September 1, 2010

**Re: Construction Storm Water Inspection at Alum Creek Trail/Franklin County.
Permit Number: 4GC02935*AG**

Figure 1: Lack of controls along river at bridge location

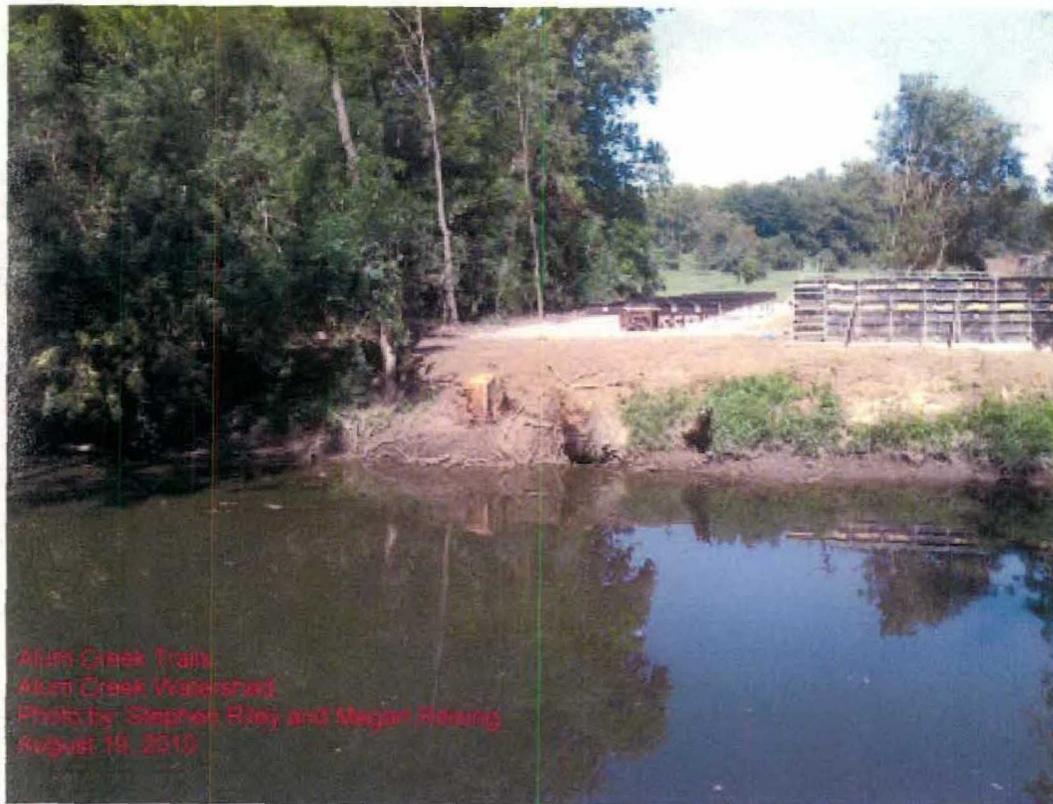
- This site appears to be relatively void of any effective sediment controls, especially at the bridge locations along the trail (Figures 1-3). The General Permit states that all sediment controls must be implemented prior to initial grading of the site. Please implement these controls immediately to ensure compliance with the General Storm Water Permit.
